PSE ACCESS CONSULTING

ACCESS/COMPLIANCE/CLARIFICATION.

SITE ADDRESS; 8 Lady Penrhyn Drive Beacon Hill. Community Centre.

Access requirements for people with disability.

FIGURE 50 SANITARY COMPARTMENT SHOWING OVERLAP OF WASHBASIN FIXTURE INTO SHOWER CIRCULATION SPACE

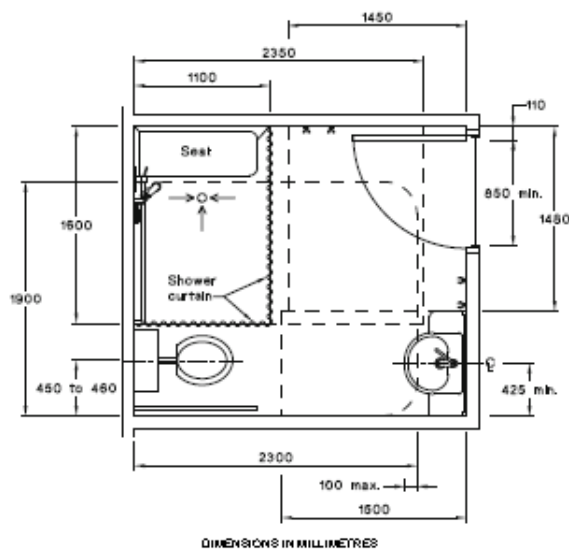
- The two change rooms/toilets for the pool/gym are of a size greater than required by AS1428.1-2009 Clause 15.2 *Accessible unisex sanitary facility* Part 15.3.2 *Accessible sole occupancy units* and two toilets on the ground floor for the reception and dining area compliant with AS1428.1-2009 Clause 15.2 *Accessible unisex sanitary facility* Figure 43.
 - i. The technical specifications (no less than the dimensions required by AS1428.1-2009 Clause 15.2 *Accessible unisex sanitary facility* Part 15.3.2 *Accessible sole occupancy units* & Figure 50 at, typically but not limited to, 2300mm X 2500mm) for this accessible (disabled) unisex sanitary facility will be as follows,
